Title: CRs to R98 (with mirror CRs) on Work Item LCS towards 23.009

CHANGE REQUEST

⌘ **04.08** **CR** **A1097** ⌘ rev **r24** ⌘ Current version: **7.11.0** ⌘

Title:	⌘ Modification to MS's MM states to enable LCS signalling on RR layer
Source:	⌘ Siemens AG, Nokia
Work item code:	⌘ LCS Date: ⌘ 08.05.01
Category:	⌘ F Release: ⌘ R98
<p>Use <u>one</u> of the following categories:</p> <p>F (essential correction) A (corresponds to a correction in an earlier release) B (Addition of feature), C (Functional modification of feature) D (Editorial modification)</p> <p>Detailed explanations of the above categories can be found in 3GPP TR 21.900.</p>	
<p>Use <u>one</u> of the following releases:</p> <p>2 (GSM Phase 2) R96 (Release 1996) R97 (Release 1997) R98 (Release 1998) R99 (Release 1999) REL-4 (Release 4) REL-5 (Release 5)</p>

Additions to Figure 4.1.a/GSM 04.08

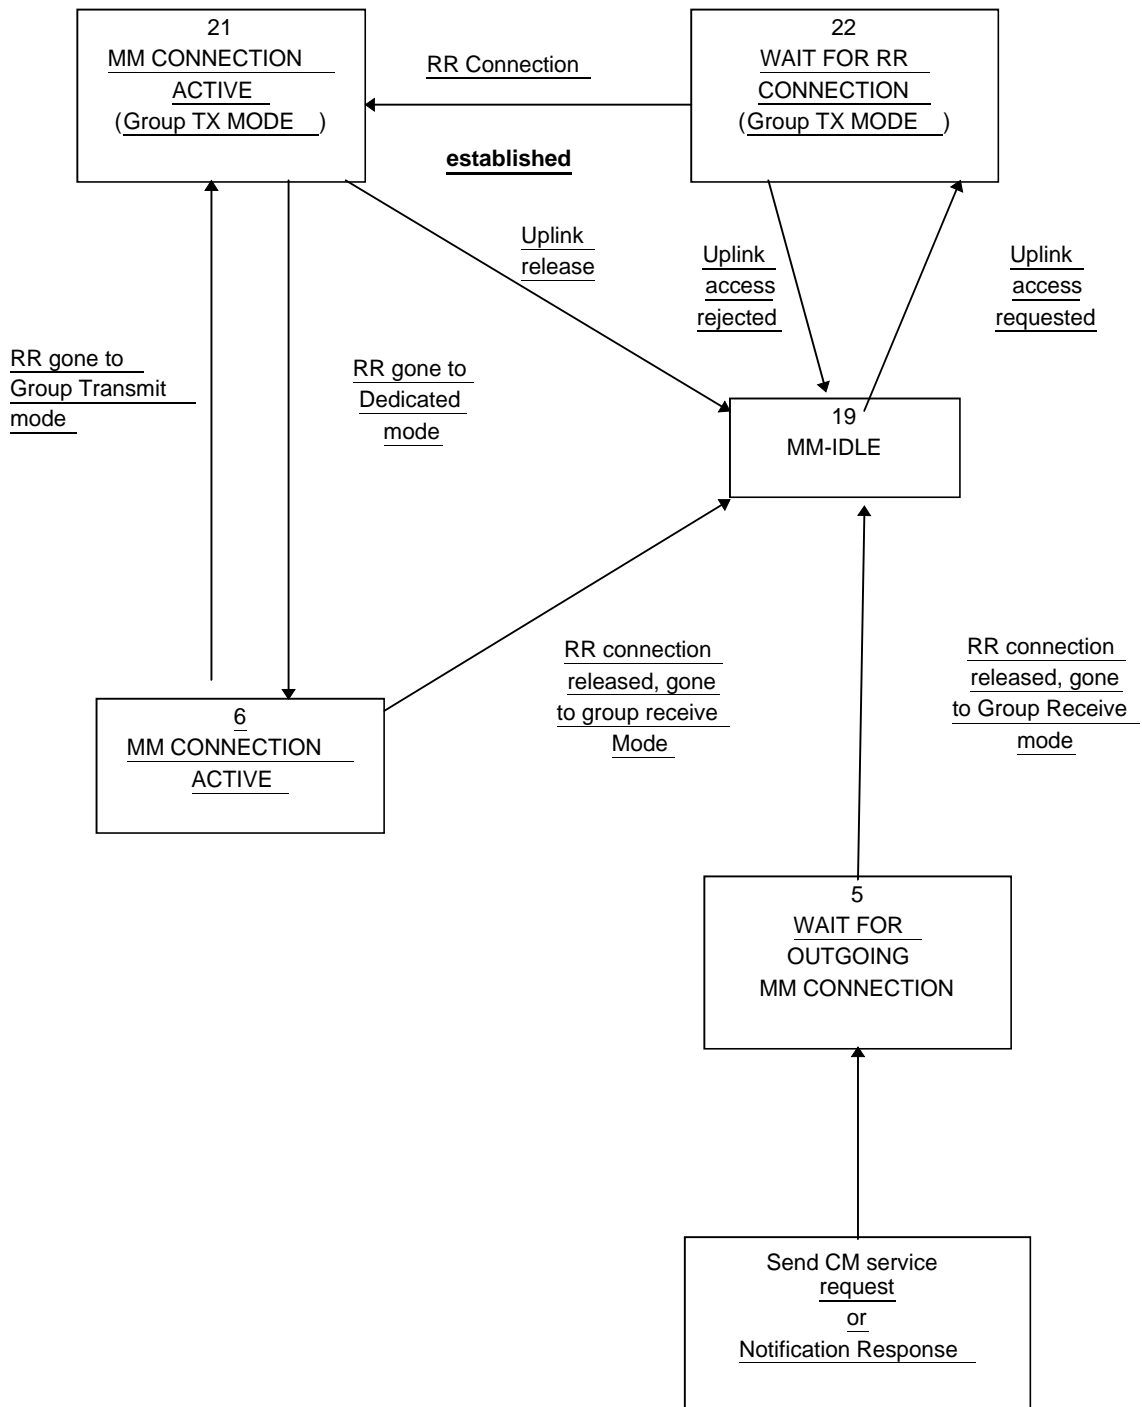
Reason for change:	⌘ As the MM layer is currently not aware of any ongoing RRLP procedure, MM will abort the RR connection if the last CM connection is released and the MM timer T3240 expires(10 sec.). This will happen during a MT-LR/NI-LR LCS positioning procedure, were the RRLP procedure may take longer than 10 seconds. In order to avoid the MS trigger abortion of the RR connection during an RRLP procedure, it is proposed to introduce a new MM state RR CONNECTION RELEASE NOT ALLOWED which is entered if no CM connections are active, but an RRLP procedure is ongoing. This state is supervised by a new introduced MM timer T3241 which ensures, that the MS does not remains in this state forever.
Summary of change:	⌘ Introduction of the new MM state RR CONNECTION RELEASE NOT ALLOWED and the corresponding MM timer T3241.
Consequences if not approved:	⌘ A ongoing RRLP procedure could not be finalised correctly due to the MS initiated abortion of the RR connection, which leads to the risk that certain LCS positioning methods will not work.

25. RR CONNECTION RELEASE NOT ALLOWED

(Only applicable for mobile stations supporting RRLP procedures). All MM connections are released by their CM entities, but the RR connection is maintained by the network due to an ongoing RRLP procedure (see GSM TS-04.31 [23b]).

Additions to Figure 4.1.a/GSM 24.008

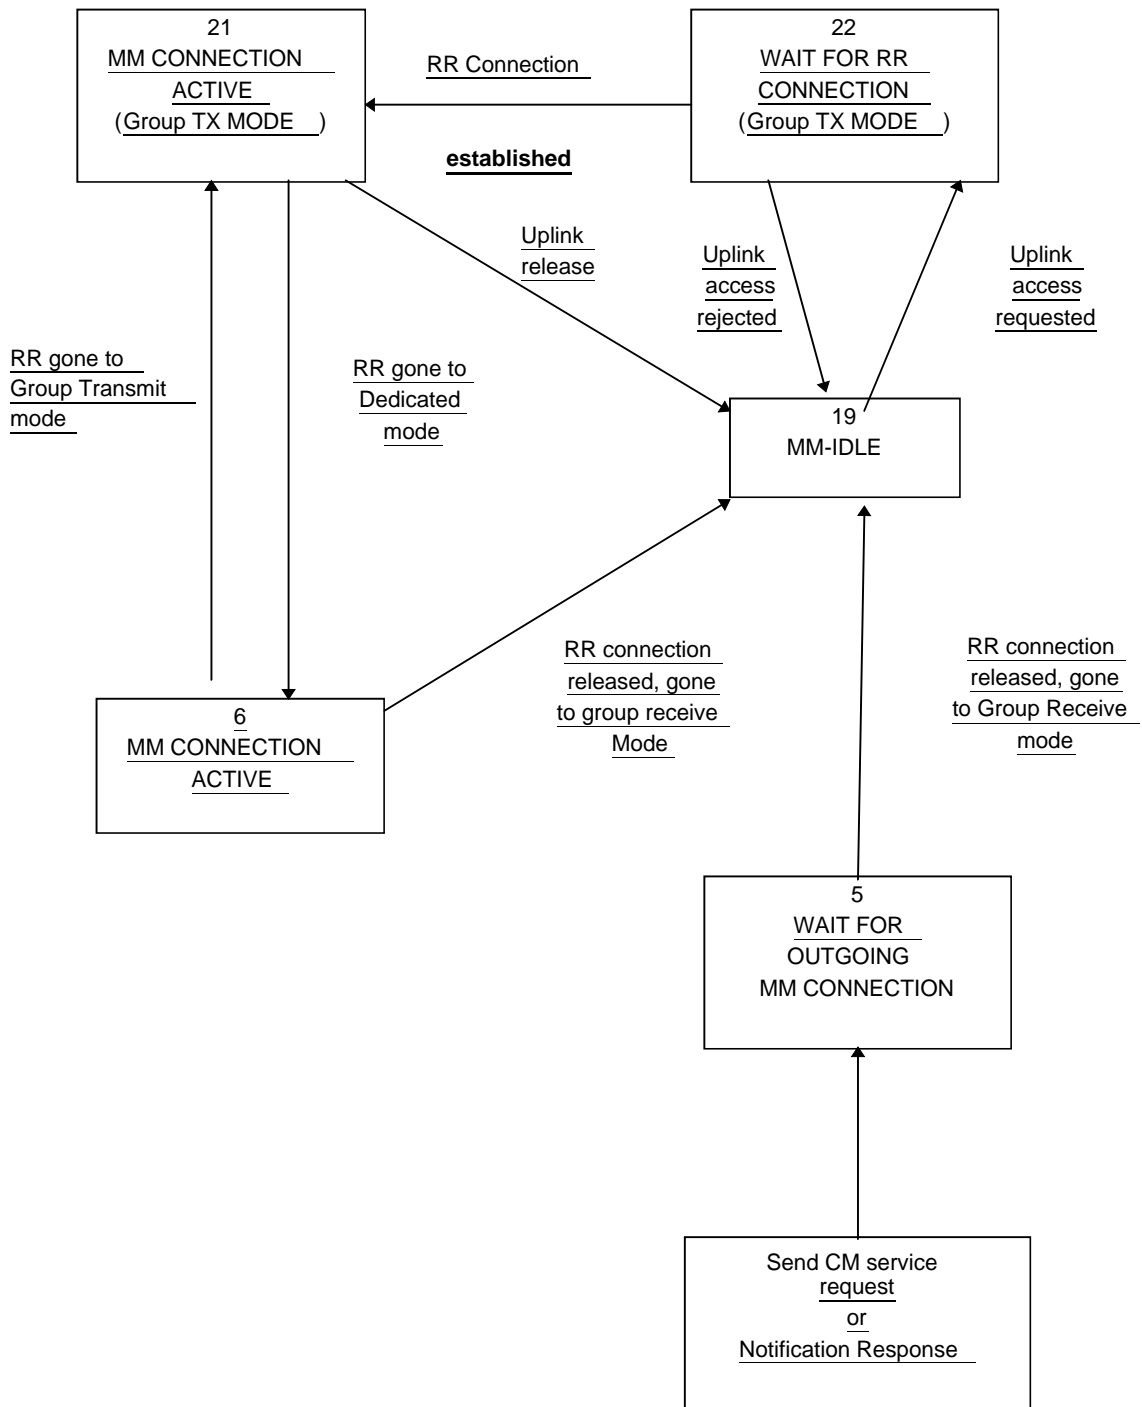
Reason for change:	⌘	As the MM layer is currently not aware of any ongoing RRLP procedure, MM will abort the RR connection if the last CM connection is released and the MM timer T3240 expires(10 sec.). This will happen during a MT-LR/NI-LR LCS positioning procedure, were the RRLP procedure may take longer than 10 seconds. In order to avoid the MS trigger abortion of the RR connection during an RRLP procedure, it is proposed to introduce a new MM state RR CONNECTION RELEASE NOT ALLOWED which is entered if no CM connections are active, but an RRLP procedure is ongoing. This state is supervised by a new introduced MM timer T3241 which ensures, that the MS does not remains in this state forever.
Summary of change:	⌘	Introduction of the new MM state RR CONNECTION RELEASE NOT ALLOWED and the corresponding MM timer T3241.
Consequences if not approved:	⌘	A ongoing RRLP procedure could not be finalised correctly due to the MS initiated abortion of the RR connection, which leads to the risk that certain LCS positioning methods will not work.

Figure 4.1a / GSM 24.008: Overview mobility management protocol / MS Side

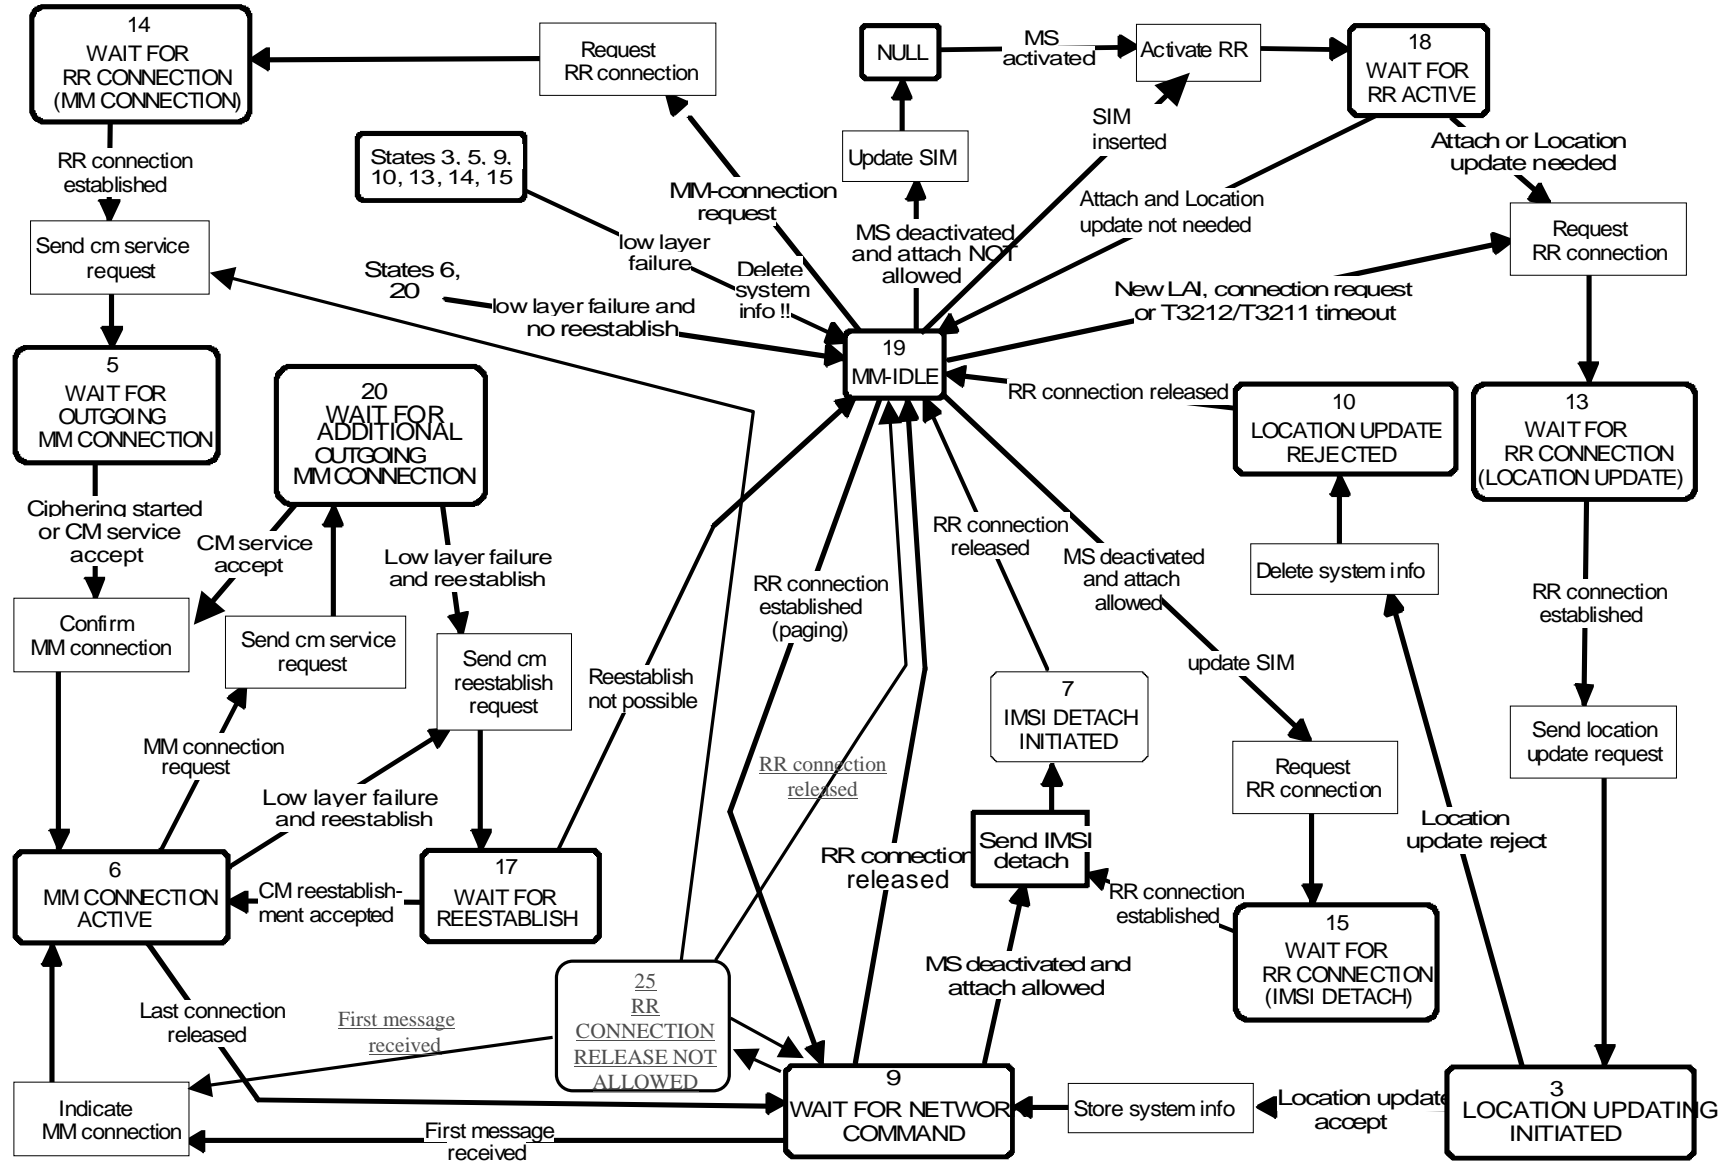
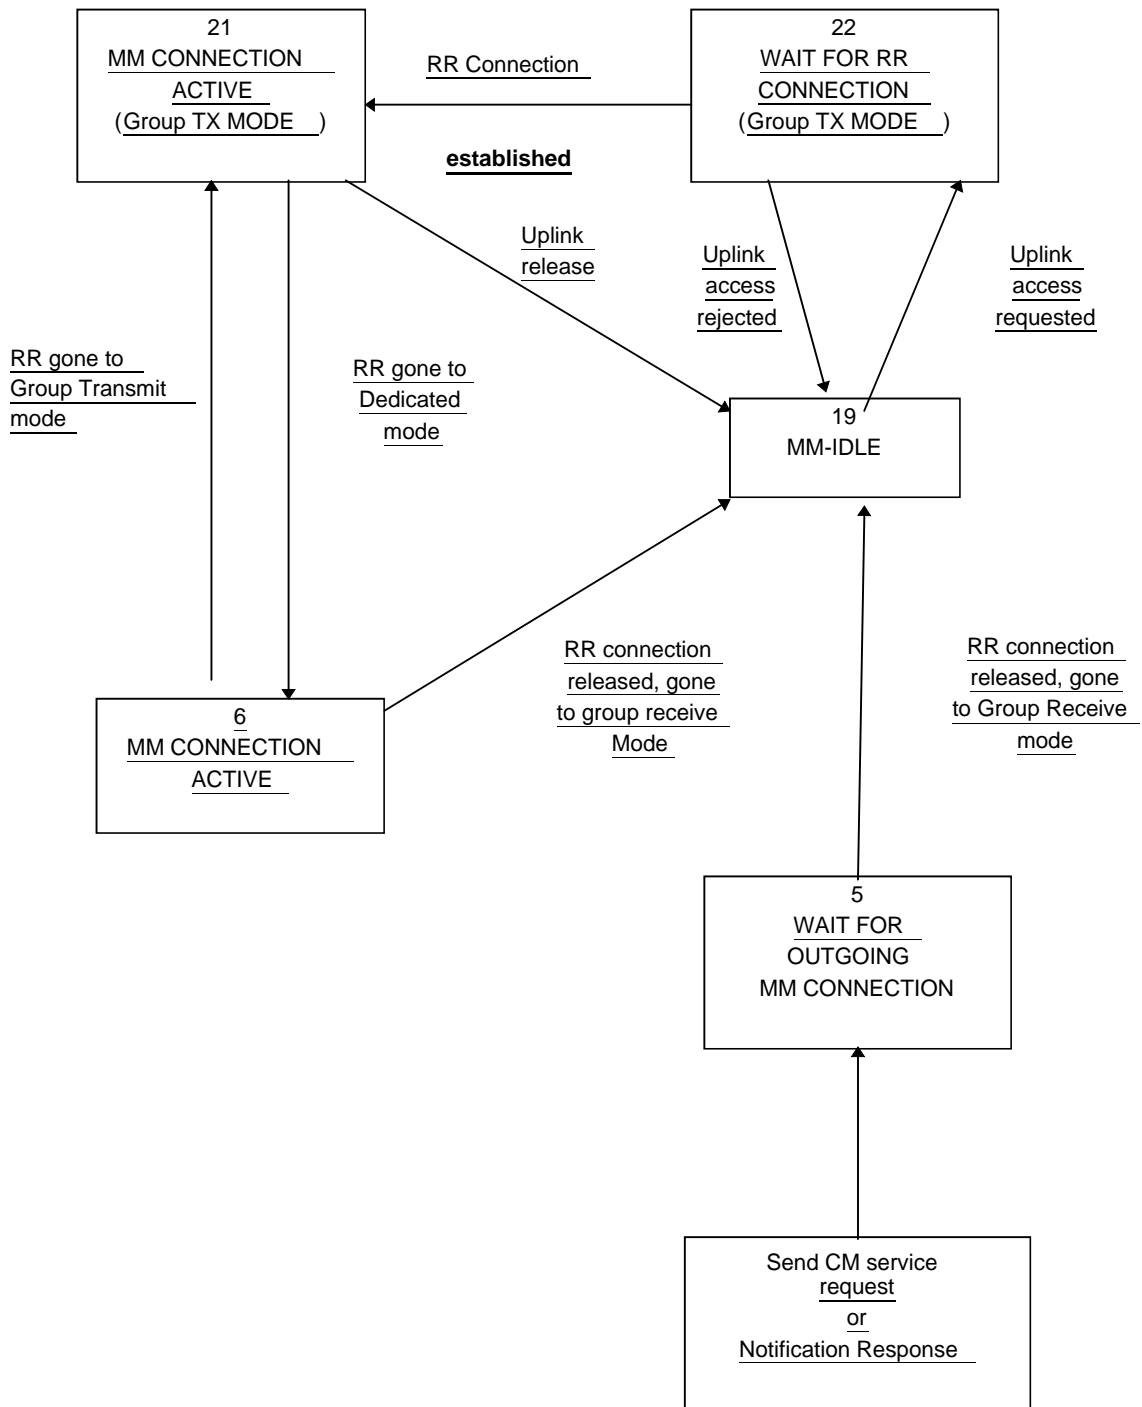
Reason for change:	⌘ As the MM layer is currently not aware of any ongoing RRLP procedure, MM will abort the RR connection if the last CM connection is released and the MM timer T3240 expires(10 sec.). This will happen during a MT-LR/NI-LR LCS positioning procedure, were the RRLP procedure may take longer than 10 seconds. In order to avoid the MS trigger abortion of the RR connection during an RRLP procedure, it is proposed to introduce a new MM state RR CONNECTION RELEASE NOT ALLOWED which is entered if no CM connections are active, but an RRLP procedure is ongoing. This state is supervised by a new introduced MM timer T3241 which ensures, that the MS does not remains in this state forever.
Summary of change:	⌘ Introduction of the new MM state RR CONNECTION RELEASE NOT ALLOWED and the corresponding MM timer T3241.
Consequences if not approved:	⌘ A ongoing RRLP procedure could not be finalised correctly due to the MS initiated abortion of the RR connection, which leads to the risk that certain LCS positioning methods will not work.
